CITY OF ALBUQUERQUE

**Planning Department
Transportation Development Services Section**

Re: Certification Submittal for a Permanent Building Certificate of Occupancy
(C.O.) for Kelly Liquor's, [B-10/ D0003C2]
6531 Paradise Blvd. NW
Architect's Stamp Dated 08/09/10

KELLY LIQUOR'S
SITE PLAN
ALBUQUERQUE, NEW MEXICO
PROJECT #0860

1 SITE PLAN
1"=20'
BAR SCALE
(IN FEET)

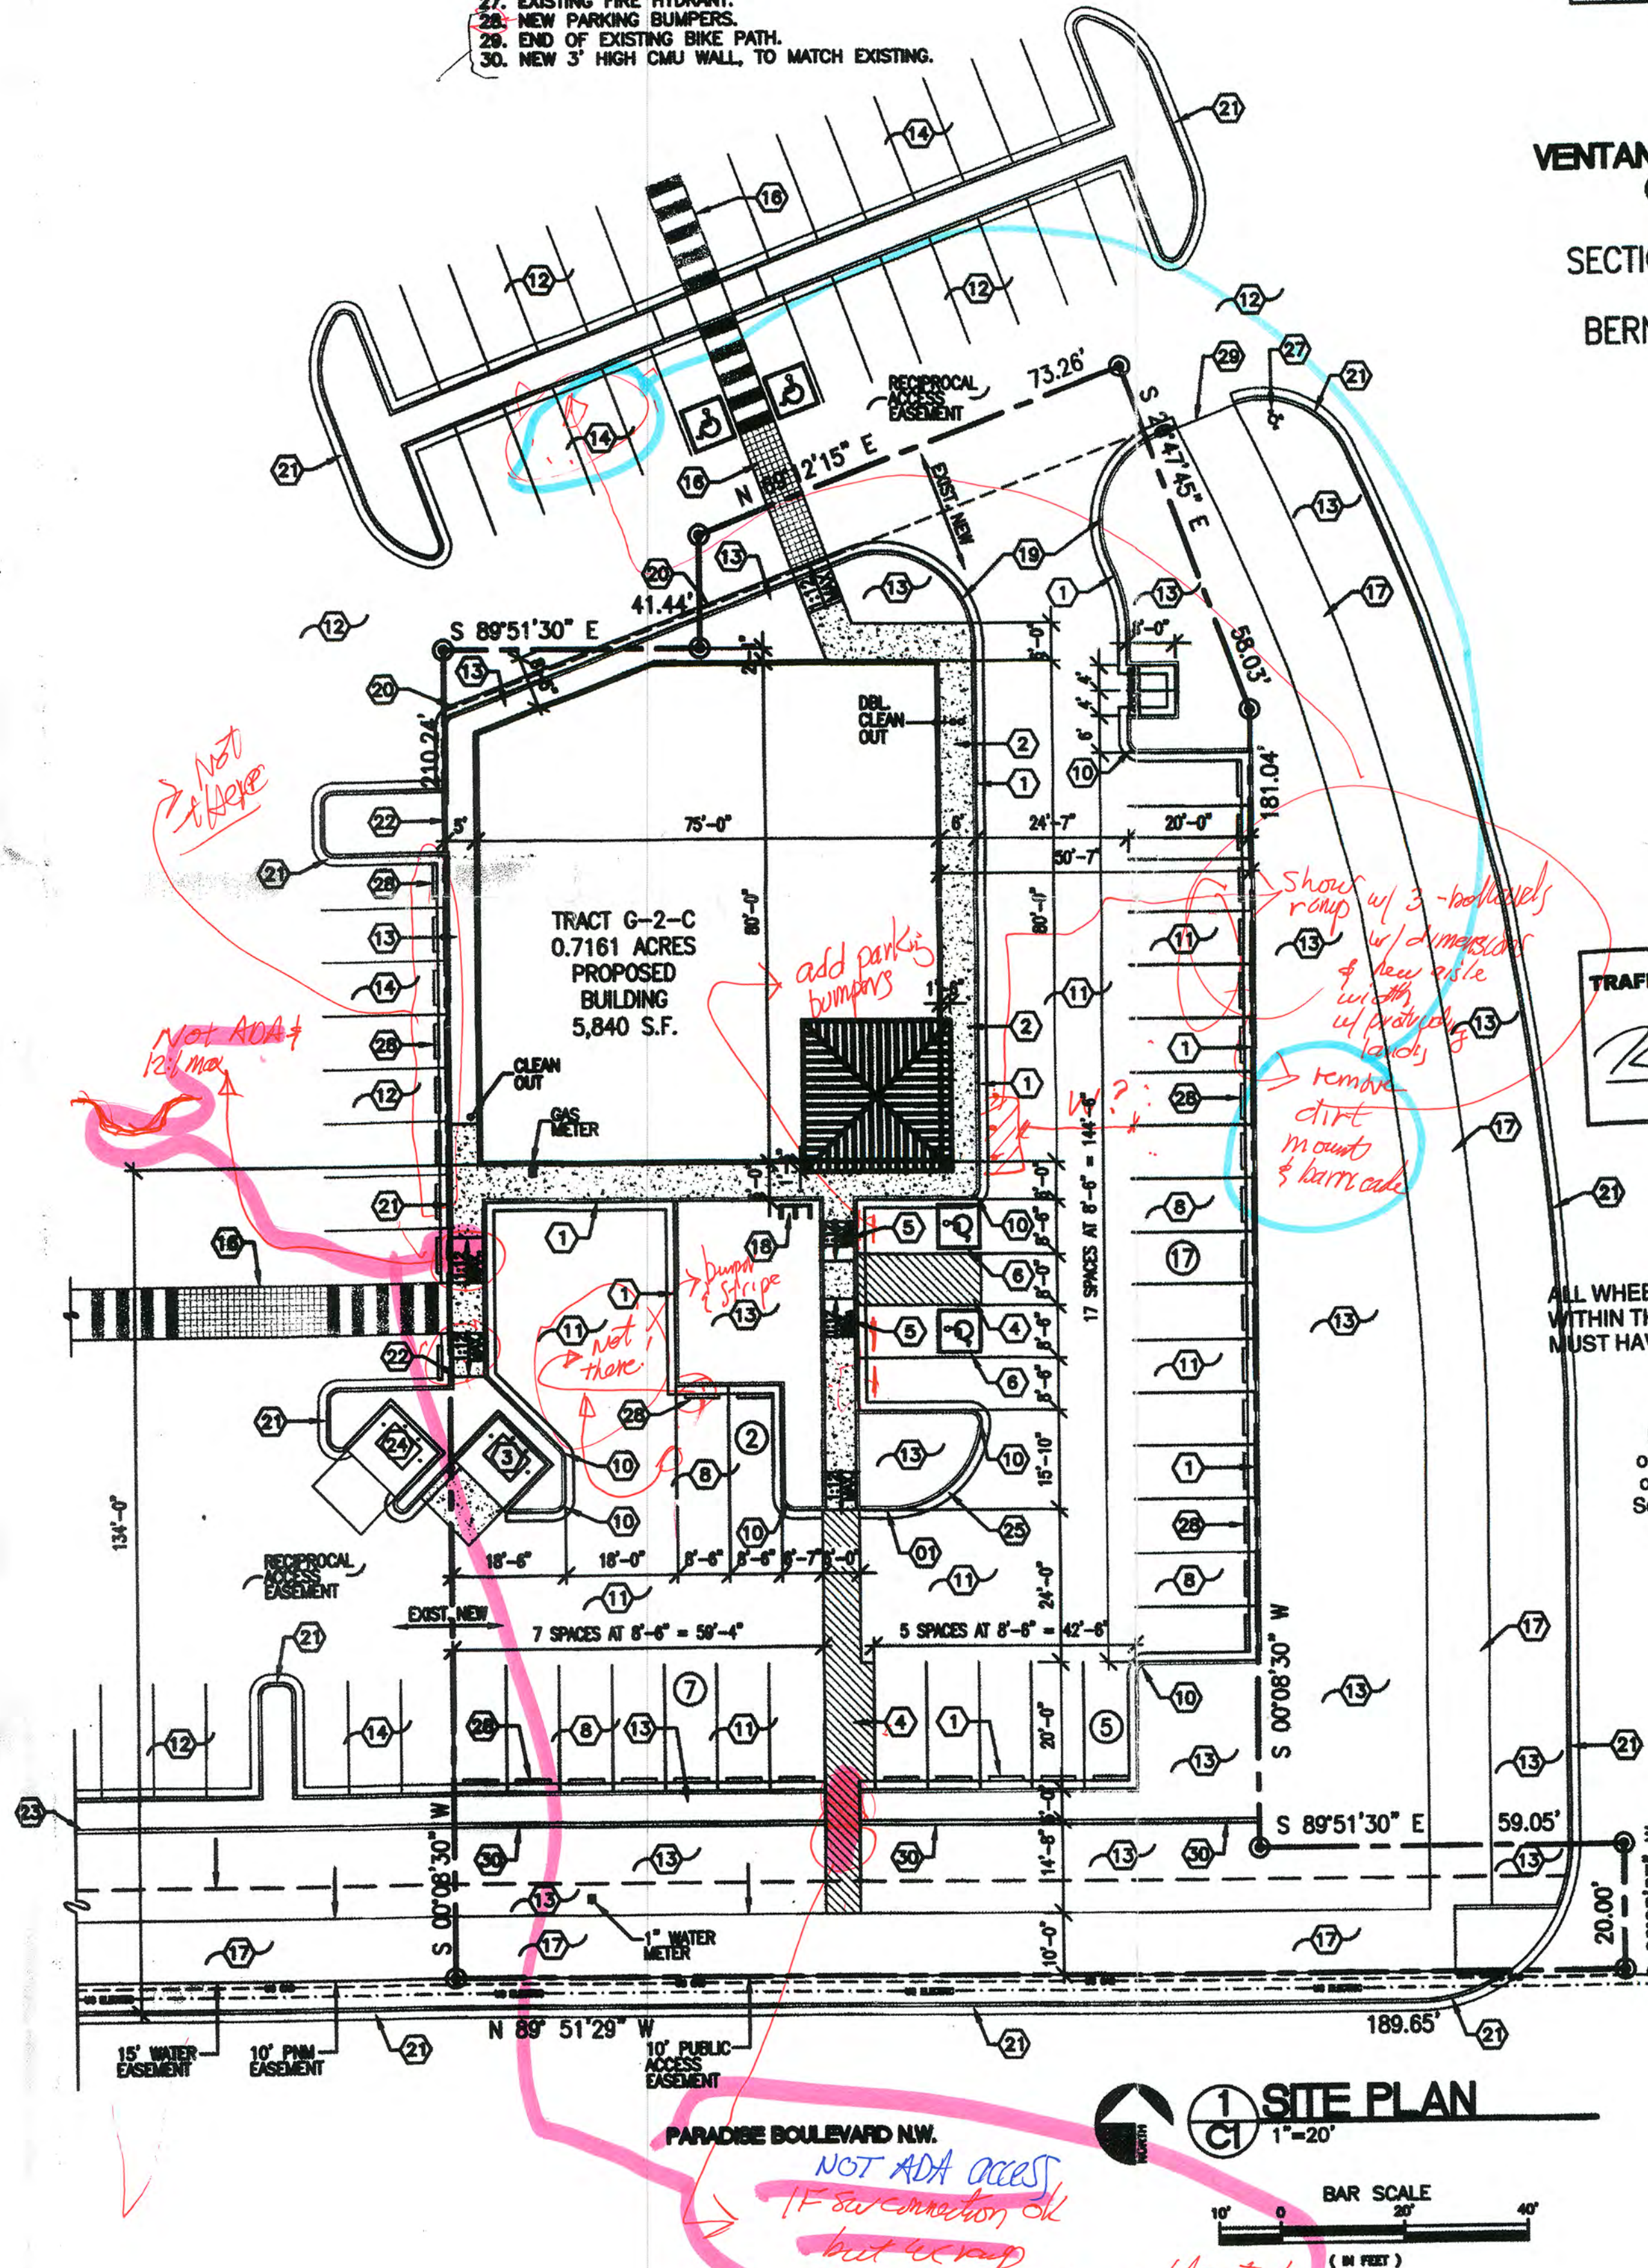
The following items will need to be addressed prior to issuance of a Permanent/temporary Certificate of Occupancy: **There are missing parking bumpers (parking stalls facing KFC site and delivery area) and required bumpers (at ADA parking stalls) which need to be installed per Site Plan key notes; remove dirt mount and barricade from northern parking stalls; please show new ramp with bollards in front of store entrance (provide dimensions of ramp and adjusted aisle width and mark the stalls as COMPACT (which are affected by the ramp and ramp will need to be painted yellow at entrance lip); all ramps and sidewalk connections need to be ADA accessible onto site (which they are not ADA accessible).** Once, these issues have been addressed you'll need to re-submit the total package for Permanent C.O. **(please redline all changes on the approved Site Plan as part of the re-submittal package).**
